ELLINIS
FALSE BOW
1/2" = 1 FOOT

REMARKS OR TYPE, No. 964

MAIN DECK

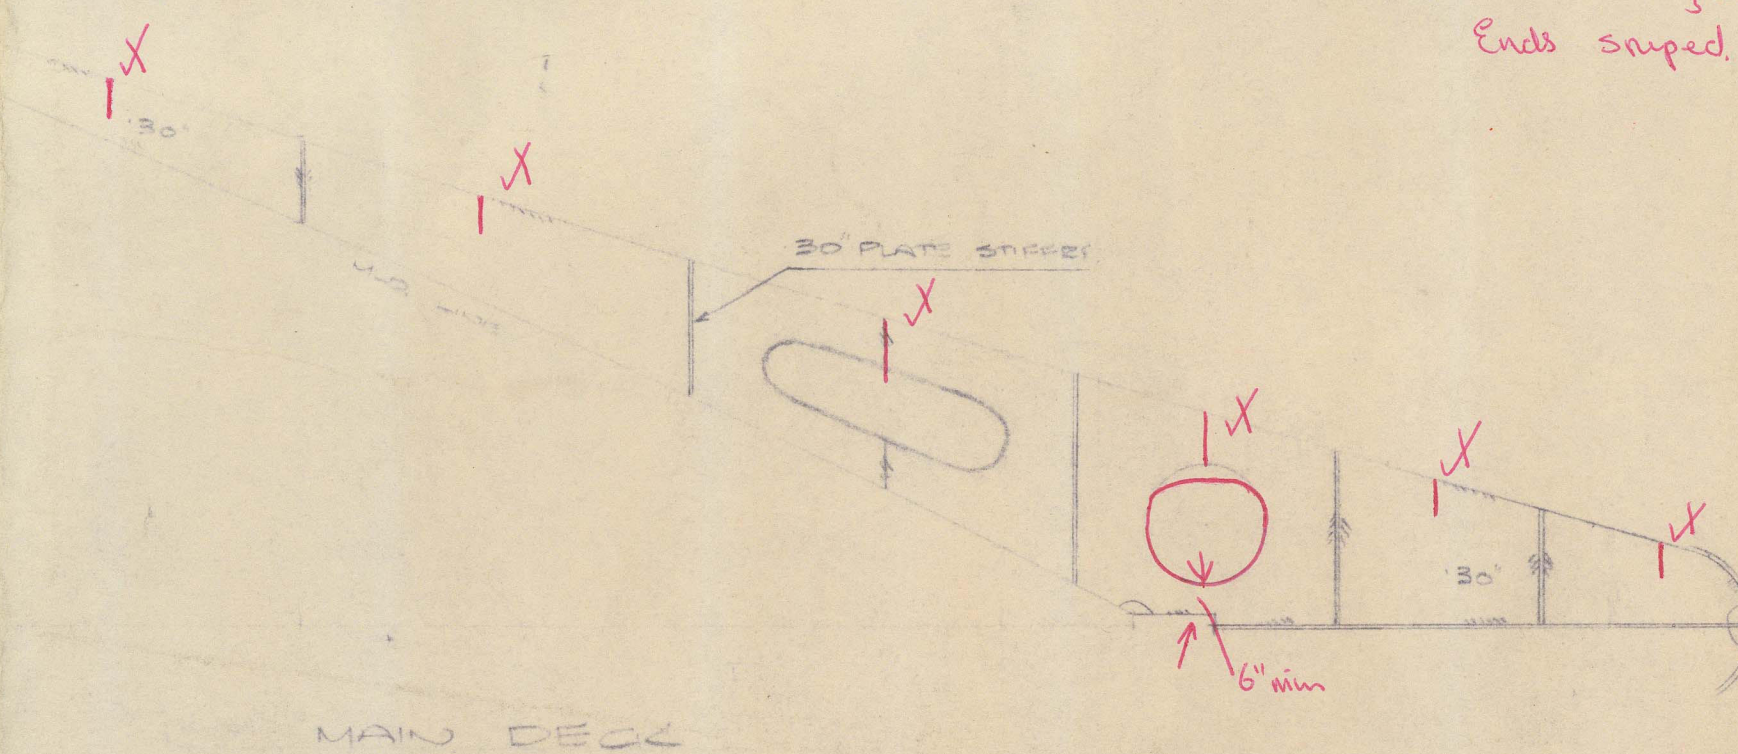
Aligned to Surveyor satisfaction

7 x 3/4" F.B. Stiffers introduced between longitudinal webs. Ends splayed

SECTION OF TYPICAL VERTICAL WEB STIFFENER

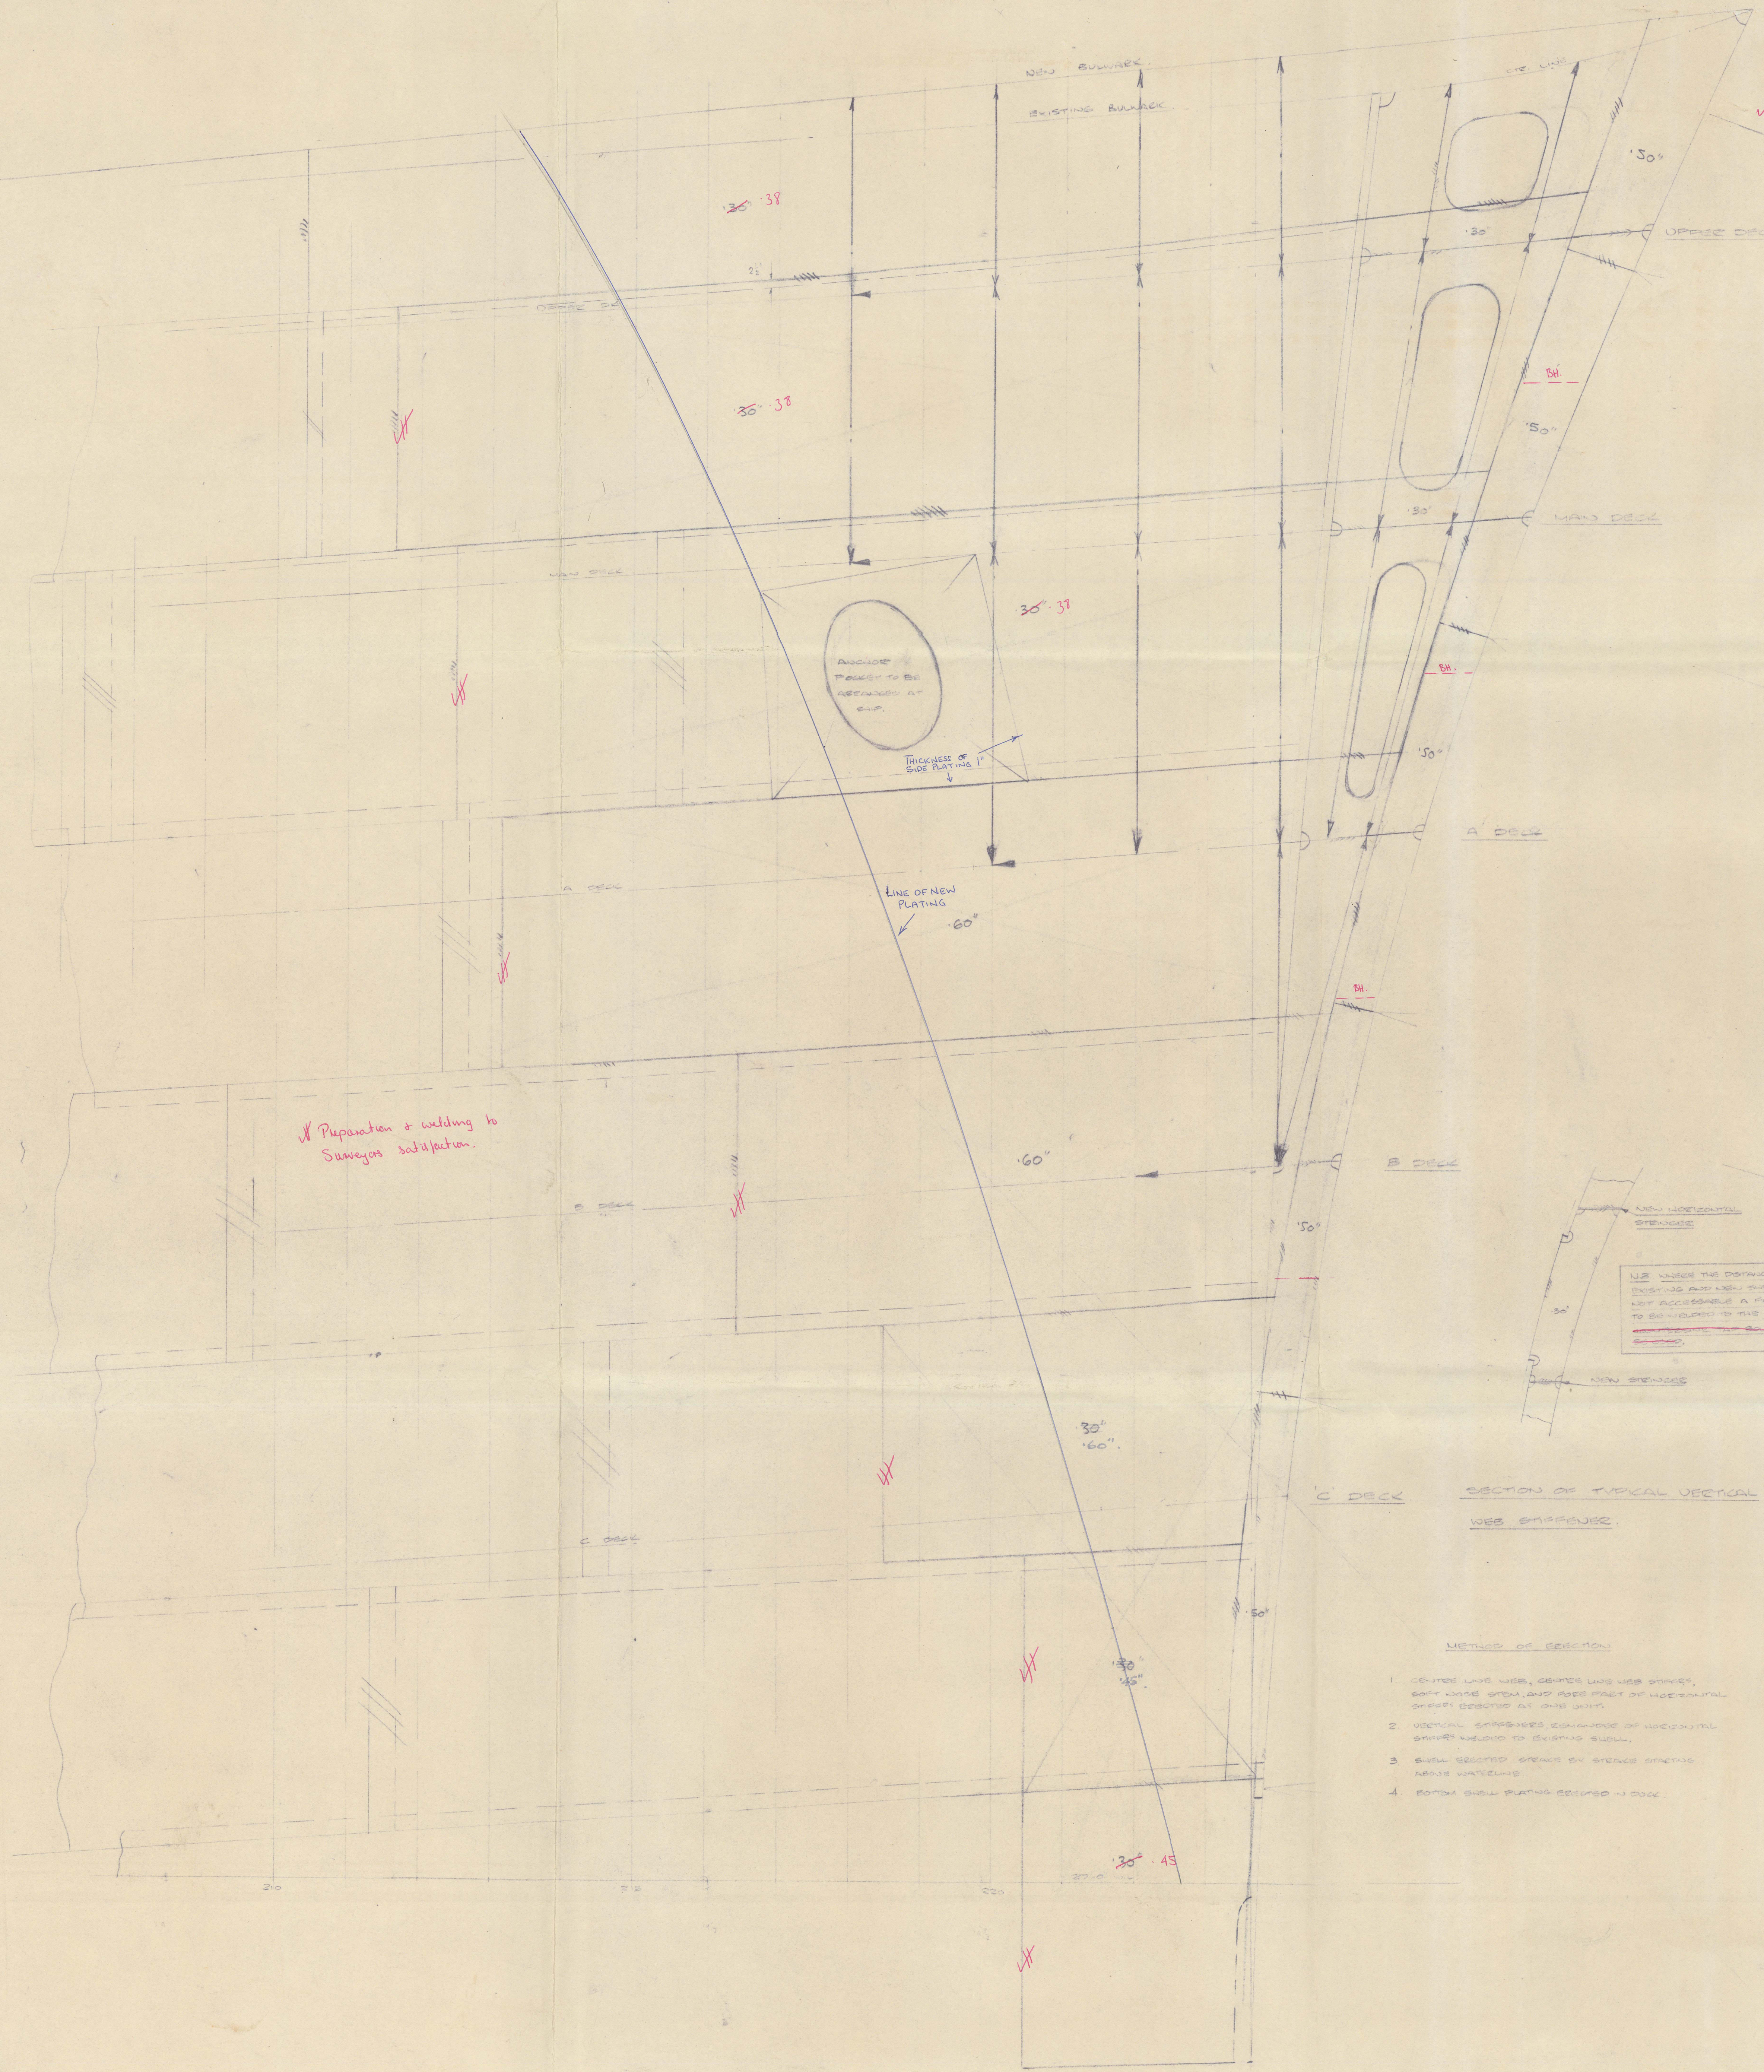
Additional panel stiffening arranged at ship to Surveyor satisfaction

Preparation & welding to Surveyor satisfaction

Slot welds adopted. Details to Surveyor satisfaction
